DESIGN HISTORY

Access and Handhole Covers

**ACCESS COVER AND HANDHOLE COVER
(AFTER SEPTEMBER 2001)**

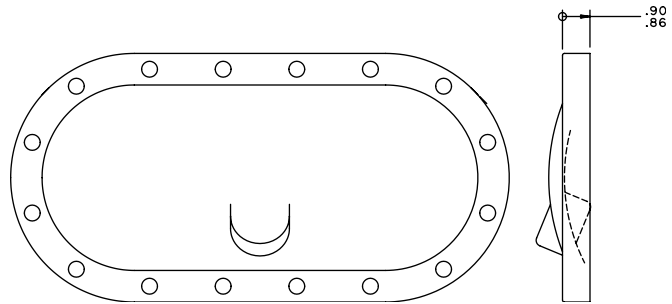
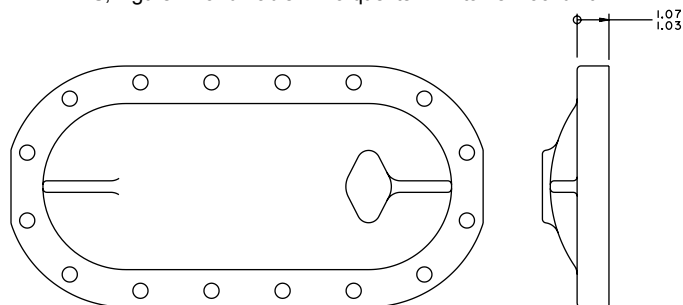
P Compressors, Styles A and B, were produced with the access and handhole covers machined from two different castings through September 2001. The flange thickness of the access cover is greater than that of the handhole covers and requires longer screws.

Beginning in October 2001, P Compressors use only access covers. Handhole covers will no longer be produced and should not, under any circumstances, be used to service P compressors produced after September 2001.

The access cover flange is nominally .17 inch (.13 - .21 inch) thicker than the handhole cover flange. The screw used with the access cover is nominally .25 inch (.19 - .31 inch) longer than the screw used with the handhole cover. The shorter screw, previously specified for use with the handhole cover, may not have adequate thread engagement if used with the access cover. The longer screw, specified for use with the access cover, may “bottom out” in the threaded hole tapped for the shorter screw. Make certain all of the sixteen (16) longer screws, securing an access cover replacing a handhole cover, do NOT “BOTTOM OUT”. Increase the depth of the threaded hole by manually tapping additional threads if necessary. Failure to observe this precaution may result in gasket leaks.

HANDHOLE COVER THROUGH SEPTEMBER 2001		
ITEM	DESCRIPTION	PART NO.
207	HANDHOLE COVER	064-21645-000
35	SCREW, HEX FLANGE, .4375-14 X 1.75	021-17692-000

ITEM	DESCRIPTION	PART NO.
25	ACCESS COVER	064-48176-000
27	SCREW, HEX FLANGE, .4375-14 X 2.00	021-17693-000
